ASSESSMENT REPORT

BLOOMFIELD COLLIERY

Power Supply and Overburden Emplacement Modification (07_0087 MOD 1)

Figure 2: Proposed offset site at Congewai

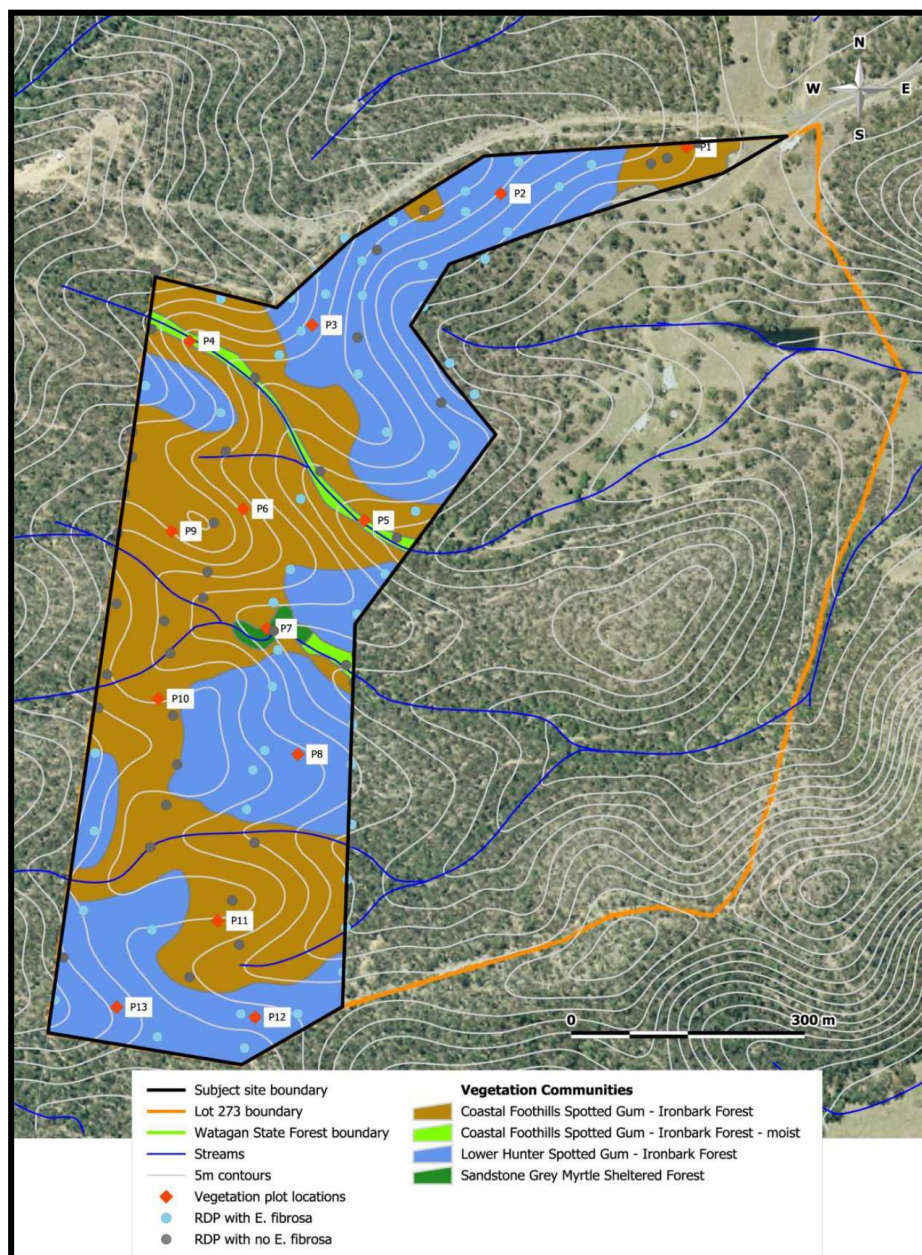
The proposed BOS is directed towards the protection of an area of land which contains the same EEC but has a higher ratio of this EEC than that proposed to be cleared, and the provision of funding for a local conservation project. Bloomfield has purchased a 40 ha parcel of land adjacent to the Watagan State Forest at Congewai, also in the Cessnock local government area (see Figure 2). This offset site includes 19.6 ha of LHSGIF EEC. This represents an offset ratio of 2.9:1 overall and 3:1 for the EEC.

Bloomfield stated that a conservative approach was taken in mapping the boundaries of the EEC at the offset site, and that there may be up to an additional 20% of the EEC at the site. The Department also notes that the site represents the known western limit of the EEC, and, as it adjoins the Watagan State Forest, the connectivity of the EEC at this site with that in the State forest would be retained.

The ecological assessment found that, despite being previously logged, the vegetation at the offset site is in good condition. The site contains a high number of habitat trees, including habitat for threatened species such as the Glossy Black-Cockatoo. The site would be protected by a covenant on its title, which would prevent the site from being developed in future.

The Department and OEH both consider that the offset site contains similar biodiversity values to those which Bloomfield proposes to clear, and that the proposed offset ratios are adequate. The Department also believes that the level of impact to LHSIGF EEC at the site Bloomfield proposes to clear would be limited, since a large amount (145 ha) of similar habitat exists in the immediate vicinity.

Figure 3: Final rehabilitation landform

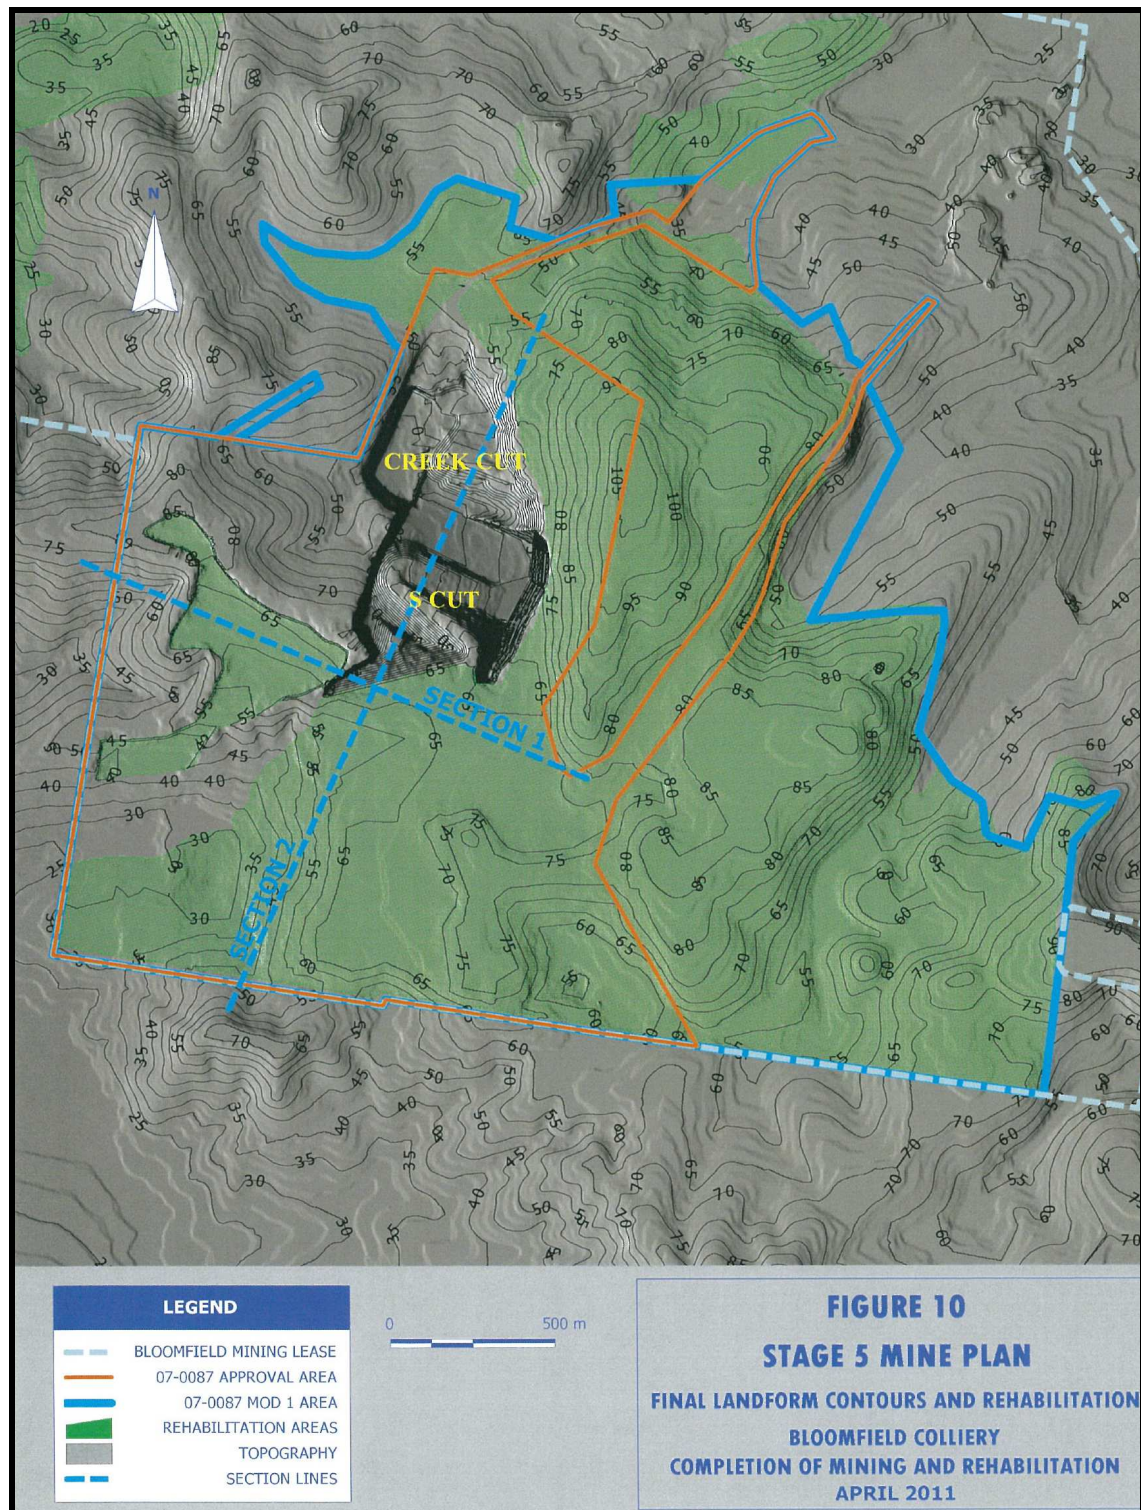
a stable, undulating landscape with a mix of pasture and tree areas suitable for grazing and general habitat. Following the emplacement of overburden, Areas B, C and E would be capped with topsoil material and sown with pasture or tree seed mix to create a stable landscape with the potential for light grazing. Trees would be planted to create habitat linkage and reduce overall visual impacts. The updated conceptual final rehabilitated landform is shown in Figure 3.

The Department considers that Bloomfield's continued rehabilitation proposals are appropriate, and that progressively rehabilitating Areas B, C and E would allow these areas to be integrated with surrounding rural land uses. As can be seen from Figure 3, the proposed final landform is well-integrated within the surrounding topography, with the exception of a relatively small final void. No significant change to existing conditions relating to rehabilitation are proposed.

Figure 4: Noise receptors

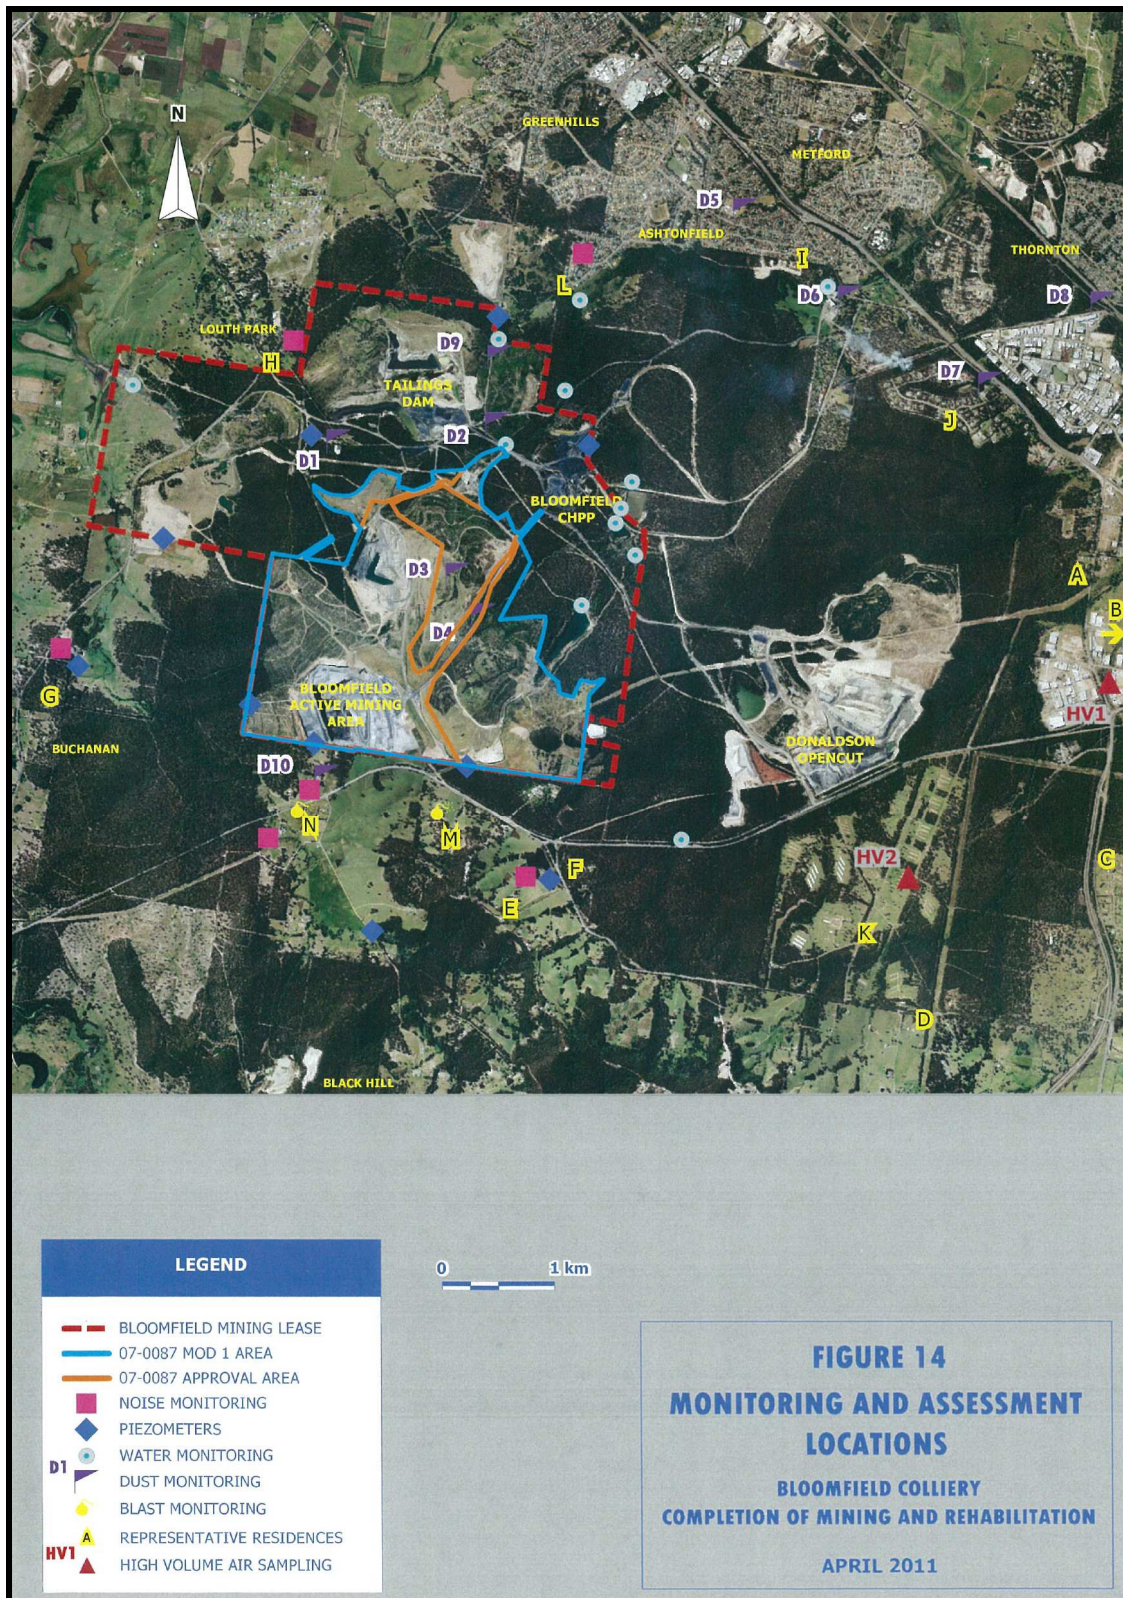
The noise assessment for the proposed modification found that overburden emplacement in Area B and Area E would lead to exceedences of approved day-time noise limits of up to 7 dB(A) at location M and up to 6 dB(A) at locations E and F (see Figure 4 for receptor locations). Minor exceedences (up to 2 dB(A)) at E and F are also predicted during the morning shoulder period (6 am to 7 am) under prevailing northwest wind conditions. Exceedences of up to 4 dB(A) for the approved evening period limit are also predicted at location L under southeast wind conditions. No exceedences are predicted to occur during emplacement in Area C.

Under normal circumstances, these predicted exceedences would be considered to be significant. However, the Department accepts that, due to the short timeframes for overburden emplacement activities (three months in Area B, periodically over six months in the other emplacement areas), the impacts would not be sustained over a significant time period. Bloomfield would also program and manage its emplacement activities to reduce the potential for nuisance to local residents. Bloomfield's Noise Management Plan includes a protocol for dealing with noise complaints, and this protocol would continue to be applied to the mine's operations during the proposed modification.

- limiting the final height of the Area B overburden emplacement to 100 m AHD;
- restricting emplacement in the southern part of Area B to the day-time period only;
- operating equipment only in a shielded location during the morning shoulder and evening periods;
- not transporting coal from the S Cut pit during the morning shoulder period;
- constructing an 80 m long noise bund to a minimum height of 80 m AHD on the southern side of the "Save-A-Mile Highway" haul road;
- restricting emplacement in Areas C and E to the day-time period only;
- restricting the duration of dumping activities at Area E to a maximum of 70 hours of work; and
- replacing the dozer with a front-end loader at Area E once the height reaches 52 m AHD.

The Department considers that the application of these measures would assist in managing noise impacts whilst the proposed modification activities are undertaken. The Department is satisfied that noise impacts from the proposed modification are unlikely to be significant overall and that no additional conditions of approval relating to noise are required.
